Handling Open Comments

Resubmitted Comments

Discussion of Comments 10016, 10017, 10018

These are open comment #16, #17, & #18 from Draft 1.0 – Cable Assembly COM

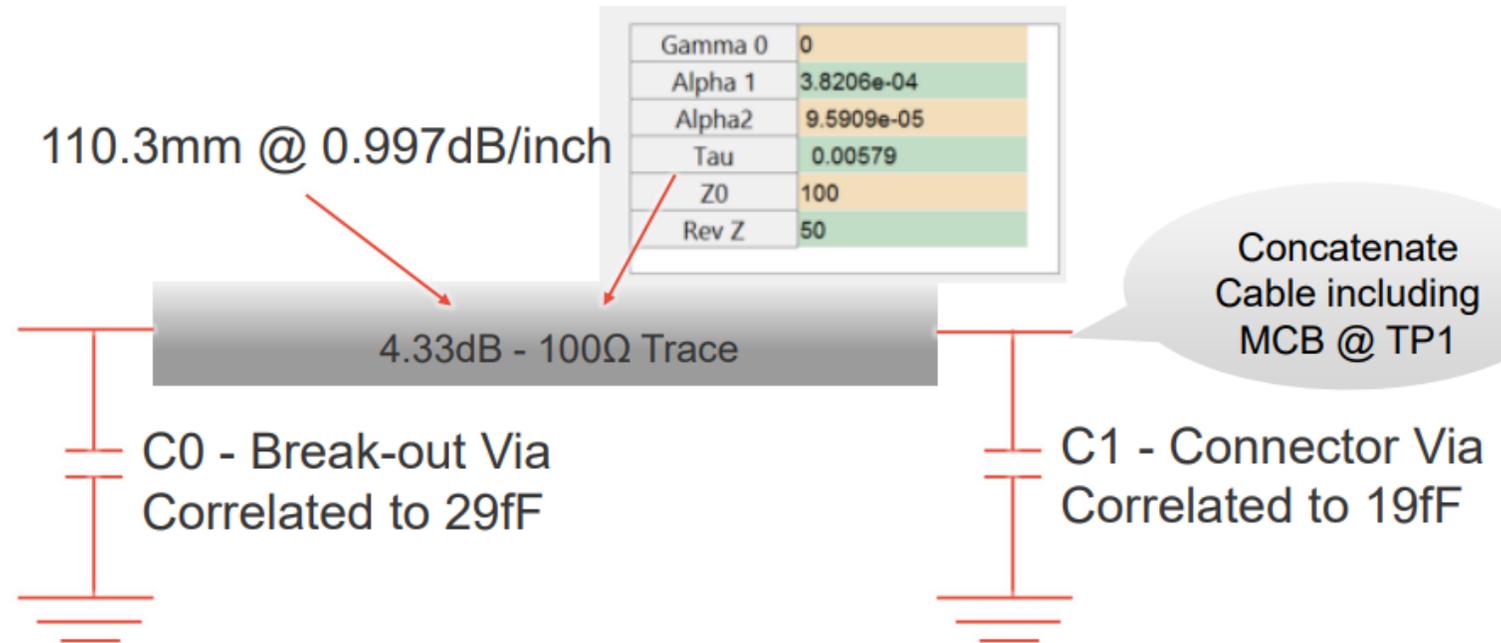
<i>Cl</i> 162	<i>SC</i> 162.11.7.1	<i>P</i> 153	<i>L</i> 28	# 16
Mellitz, Richard		Samtec		
<i>Comment Type</i>	TR	<i>Comment Status</i>	D	
Fill in Zp TBD's with data from slide 8 of benartsi_3ck_01a_0719.				
<i>SuggestedRemedy</i>				
Change Line 28ff to Equation (93A-13) and Equation (93A-14) using zp = 110.3 mm in length and the parameter values given in {new table}, with the exception that Zc is 100 O, representing an insertion loss of 4.33 dB at 26.56 GHz on each PCB				
<i>Proposed Response</i>	<i>Response Status</i>		W	
PROPOSED ACCEPT IN PRINCIPLE.				
Implement suggested remedy with editorial license.

<i>Cl</i> 162	<i>SC</i> 162.11.7.1	<i>P</i> 153	<i>L</i> 28	# 17
Mellitz, Richard		Samtec		
<i>Comment Type</i>	TR	<i>Comment Status</i>	D	
add {new table for 93A transmission line with data from slide 8 of benartsi_3ck_01a_0719.				
<i>SuggestedRemedy</i>				
gamma0, a1, a2 = [0 3.8206e-04 9.5909e-05]; tau=5.790E-03 ns/mm				
<i>Proposed Response</i>	<i>Response Status</i>		W	
PROPOSED ACCEPT IN PRINCIPLE.				
Implement suggested remedy with editorial license.

<i>Cl</i> 162	<i>SC</i> 162.11.7.1.2	<i>P</i> 153	<i>L</i> 51	# 18
Mellitz, Richard		Samtec		
<i>Comment Type</i>	TR	<i>Comment Status</i>	D	
Fill in TBD's with data from slide 8 of benartsi_3ck_01a_0719.				
<i>Suggested Remedy</i>				
use same data as for signal path				
<i>Proposed Response</i>		<i>Response Status</i>	W	
PROPOSED ACCEPT IN PRINCIPLE.				
[Editor's note: Changed subclause from 162.11.7.2 to 162.11.7.1.2]

Current Model to be Inserted as “Include PCB”
